Model: <b>Be-C2</b>	Date: 01-Sep-15	No.: RD211005
---------------------	-----------------	---------------

Subject: Firmware Release Note: Web Uapl		Prepared by: Y. Kurohashi	
From: 1st PP Tech Service Sect., PP Tech Service Dept.			
Classification:	<input type="checkbox"/> Troubleshooting <input type="checkbox"/> Mechanical <input type="checkbox"/> Paper path <input type="checkbox"/> Product Safety	<input type="checkbox"/> Part information <input type="checkbox"/> Electrical <input type="checkbox"/> Transmit/receive <input checked="" type="checkbox"/> Other (Firmware)	<input type="checkbox"/> Action required <input type="checkbox"/> Service manual revision <input type="checkbox"/> Retrofit information <input checked="" type="checkbox"/> Tier 2

Model: Be-C2a/b		Date: 3-Dec-15	No.: RD211021
Subject: Service Manual revision – NVRAM replacement		Prepared by: Y.Kurohashi	
From: 1st Tech Service Sect., PP Tech Service Dept.			
Classification:	<input checked="" type="checkbox"/> Troubleshooting <input type="checkbox"/> Mechanical <input type="checkbox"/> Paper path <input type="checkbox"/> Product Safety	<input type="checkbox"/> Part information <input type="checkbox"/> Electrical <inpu

AZ240226

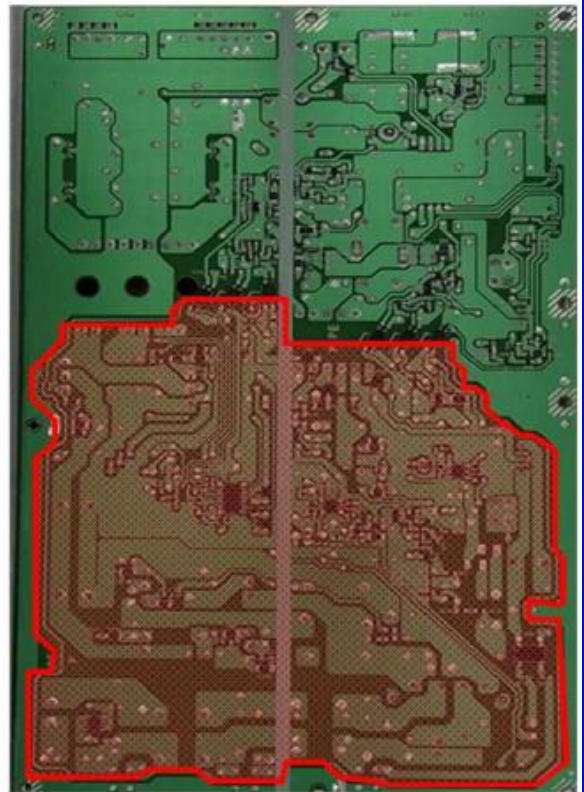
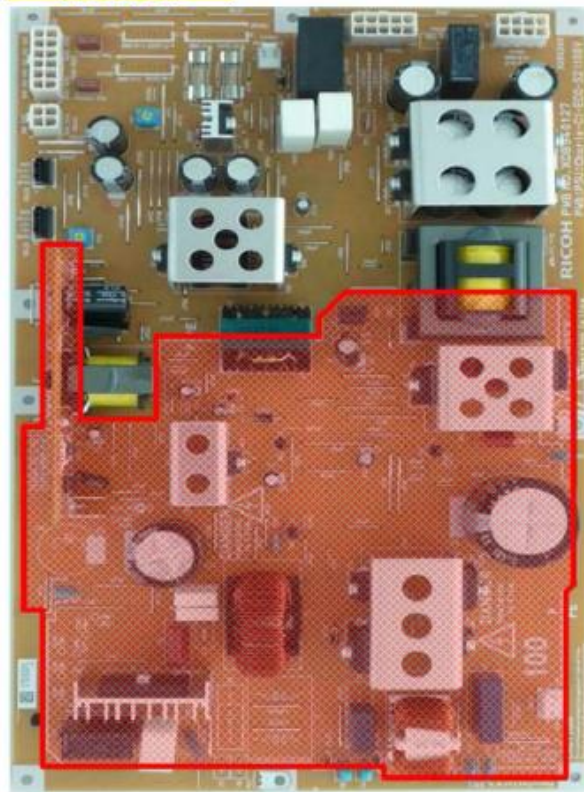
**NEVER touch** the areas outlined in red in the photos below to prevent electric shock caused by residual charge.

Residual charge of about 100V-400V remains in the AC circuits on the PSU board for several months even when the board has been removed from the machine after turning off the machine power and unplugging the power cord.

The procedure to discharge residual charge from the machine by unplugging the power cord from the AC wall outlet and pressing the main power switch works only for the DC circuits on this board. Residual charge remains in the AC circuits.

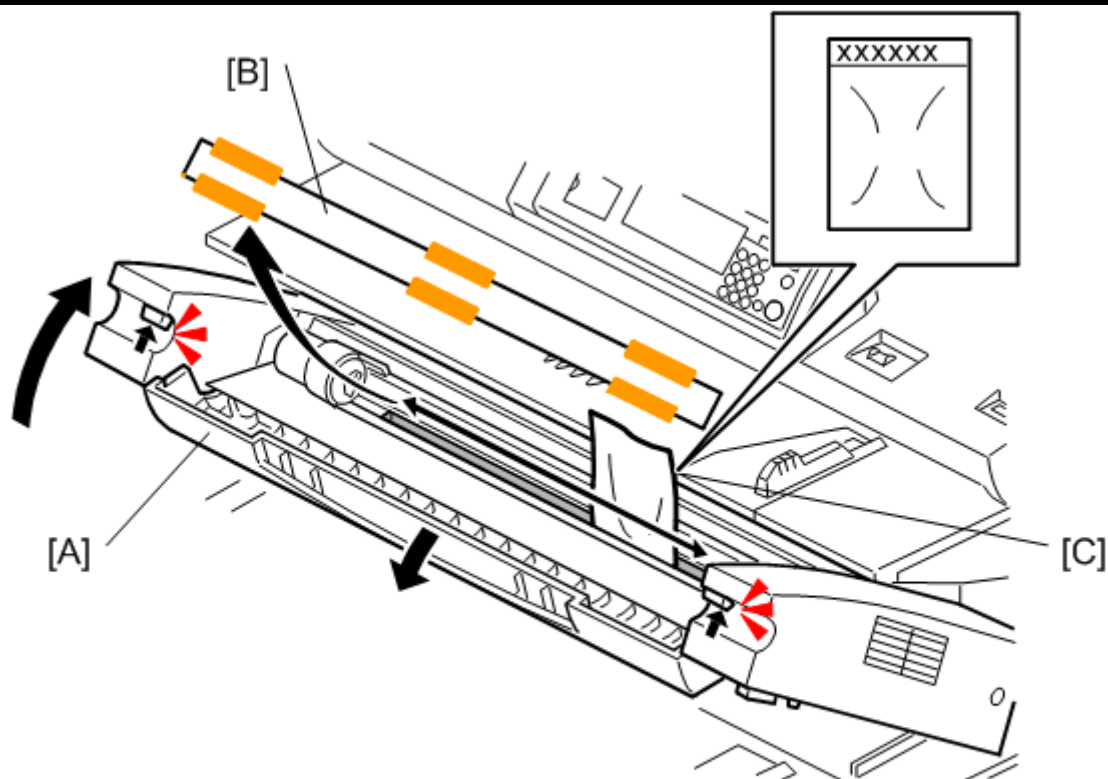
Please correct the descriptions ~~struck out~~ and in **red** to your FSM in the following section:  
 Installation > Installation Procedure > Developer and Toner

- ~~There are two 1-kg packs of toner provided. Do not open each pack until you are instructed to do so in the procedure below.~~
- **Toner and developer are not included as accessories. Procure toner and developer for new site installs. 2 packs of developer will be necessary. (As a standard procedure, toner is procured as supply and developer as service part.)**
- A developer lot number is embossed on the top edge of each package.
- Keep these top edges after you open each developer package.
- You will need these numbers when you input them later in **SP2801-2** and **-3**.
- 4. Open the first 1 kg pack of developer [C] and pour it into the development unit.
  - Slowly pour the developer into the development unit, as you move the pack from left to right until the pack is empty.
  - An equal amount of developer must be spread along the entire open slot of the development unit.

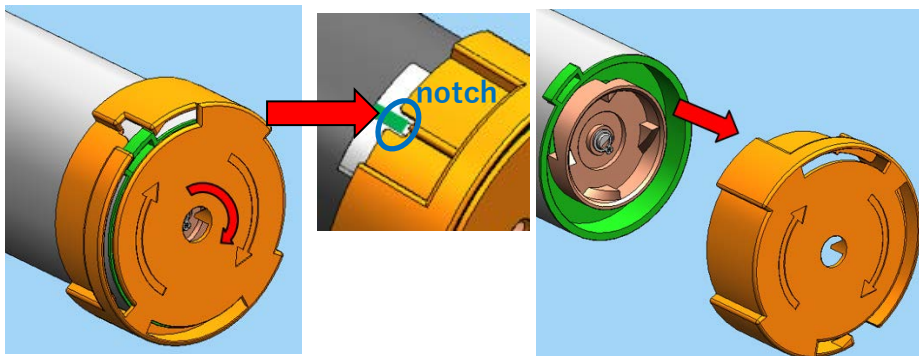
- *Show the customer how to prepare a toner cartridge for installation.*
- *A toner cartridge should never be put on its end or stored vertically.*
- *Do not remove the tape from new toner cartridge at this time.*
- *Rotate that knob in the direction marked on it until the green line appears in the notch area. Once the green line appears, pull the knob out.*

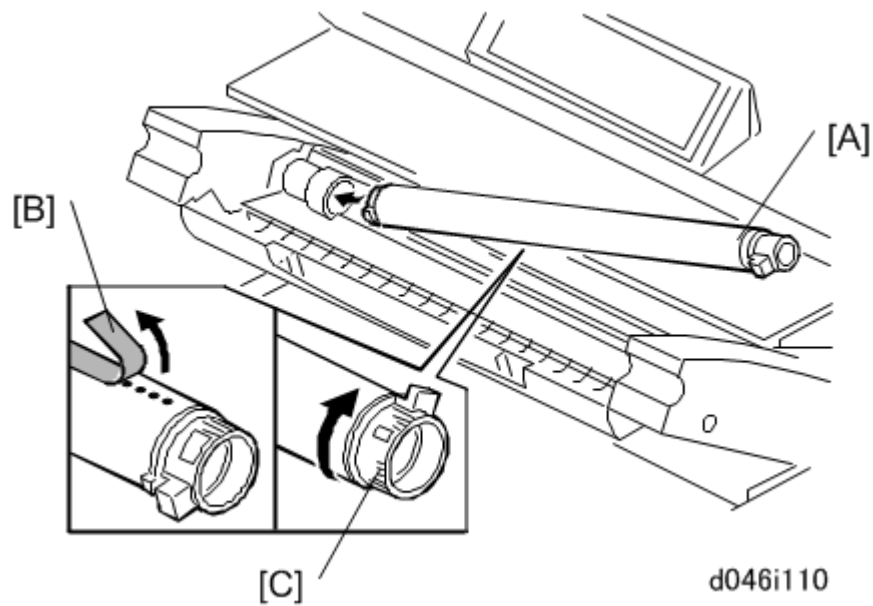
**20\*. Install the new toner cartridge[A]. (You can refer to the decal attached to the left side of the machine.)**

- *Peel off the green tape [B] from right to left to expose the perforated clear tape (these are the toner supply holes). (This clear tape is not removed.)*
- *Rotate the knob [C] until it stops.*

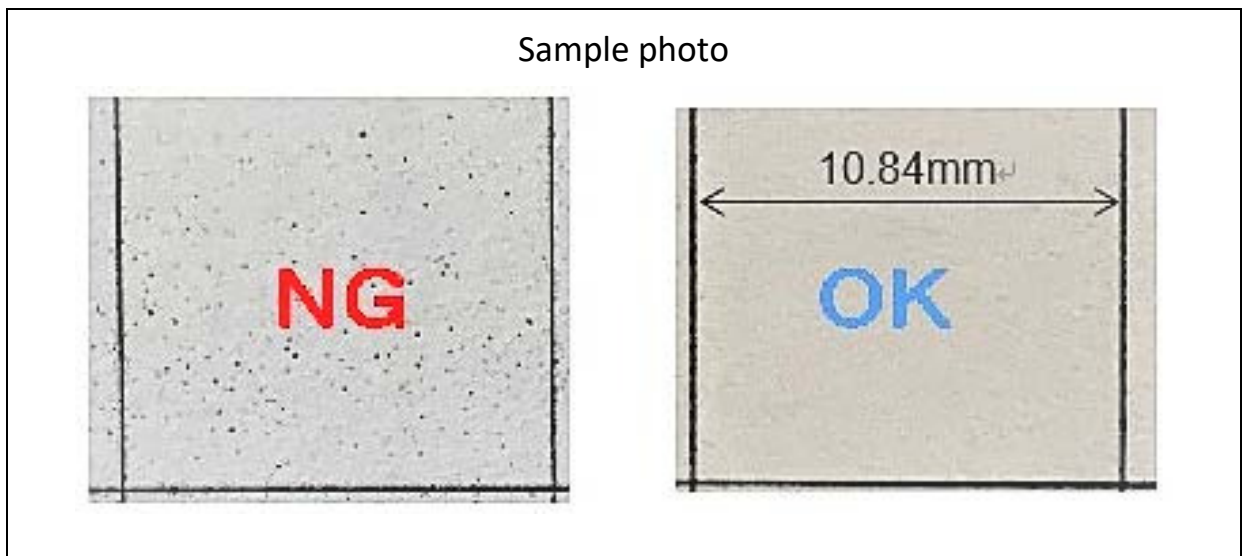
- Never incinerate used toner or toner cartridges.
- Toner and toner cartridges are thrown into the fire can ignite or explode and cause serious injury. At the work site always carefully wrap used toner and toner cartridges with plastic bags to avoid spillage before disposal or removal
- **Never attempt to disassemble a pneumatic arm charged with gas under high pressure or throw it into a fire.**
